Washington State Department of Transportation

SR 305
SUQUAMISH WAY IMPROVEMENTS
MP 7.19

PRELIMINARY LAYOUT 2/20/2015

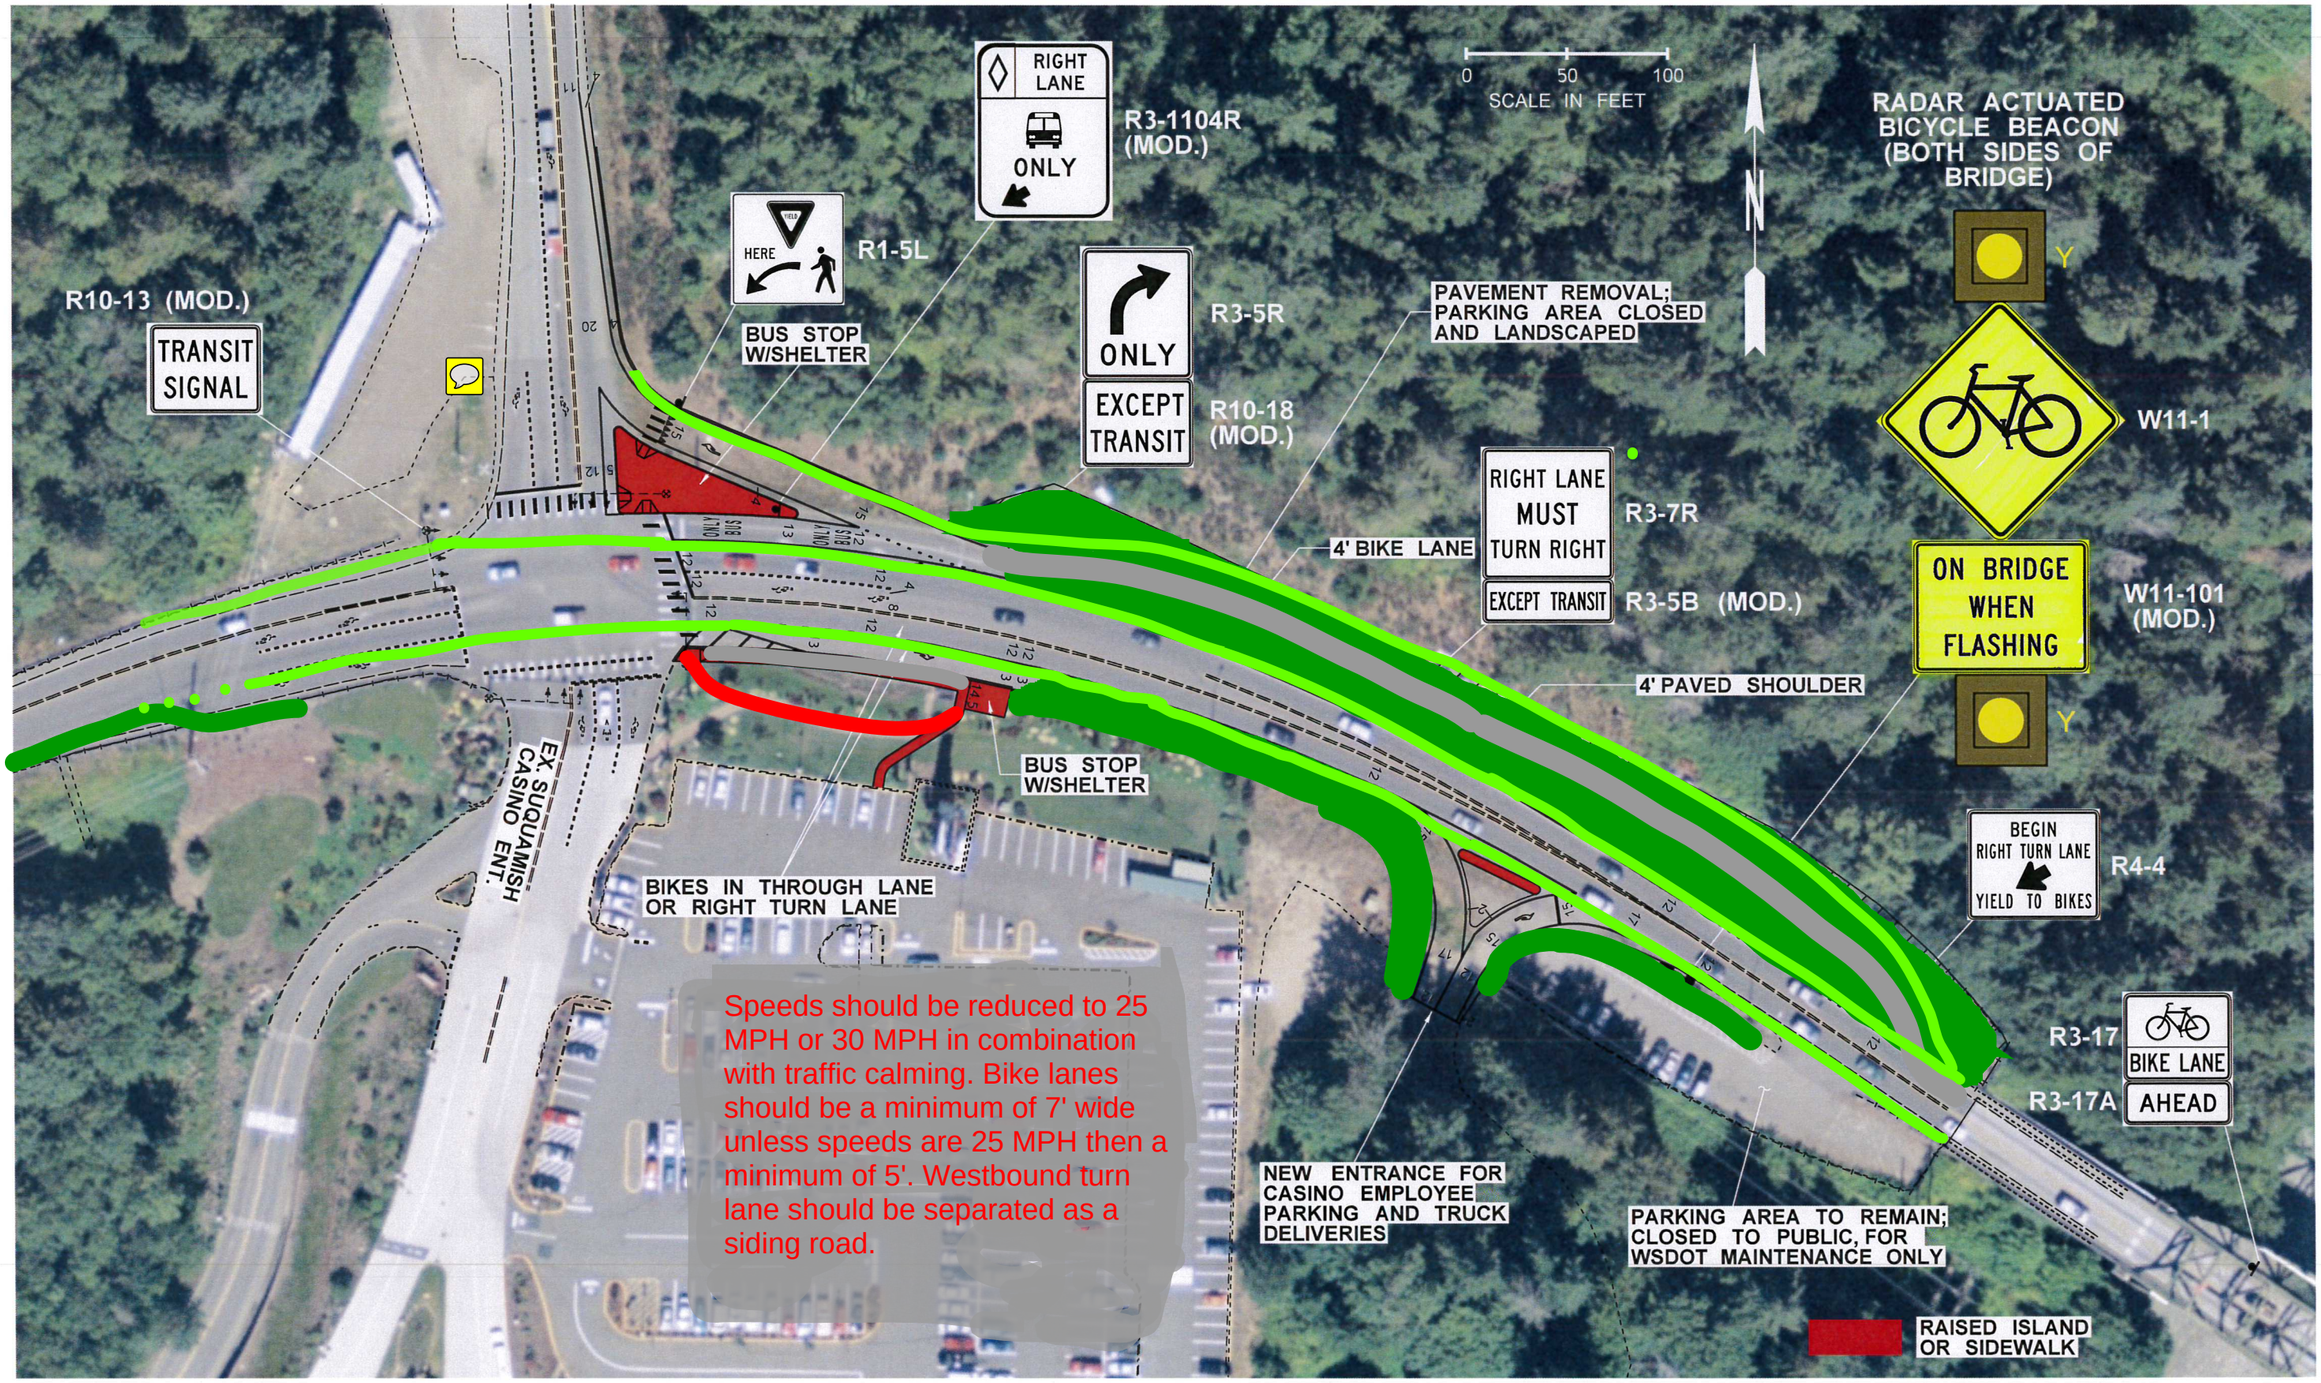
Speeds should be reduced to 25 MPH or 30 MPH in combination with traffic calming. Bike lanes should be a minimum of 7' wide unless speeds are 25 MPH then a minimum of 5'. Westbound turn lane should be separated as a siding road.
